AWR1642 Device Errata

This document describes the known exceptions to the functional and performance specifications to TI CMOS Radar Devices (AWR1642).

Figure 1. Example of Device Part Markings

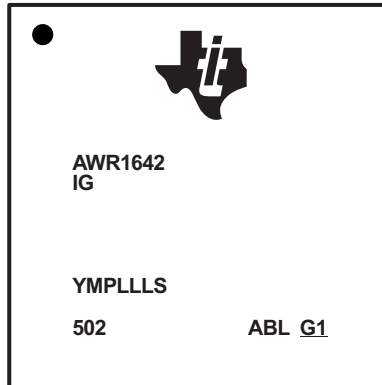
Changes from Original (May 2017) to A Revision	Page
• Updated/Changed <i>Example of Device Part Markings</i> from "946D" to "502"	2
• Updated/Changed <i>Example of Device Part Markings</i> from "XAWR1642" to "AWR1642"	2
• Added ES2.0 column	4
• Added MSS#17 Advisory	7
• Added MSS#18 Advisory	8
• Added MSS#19 Advisory	8
• Added ANA#08 Advisory	8
• Added ANA#09 Advisory	9
• Added ANA#10 Advisory	9
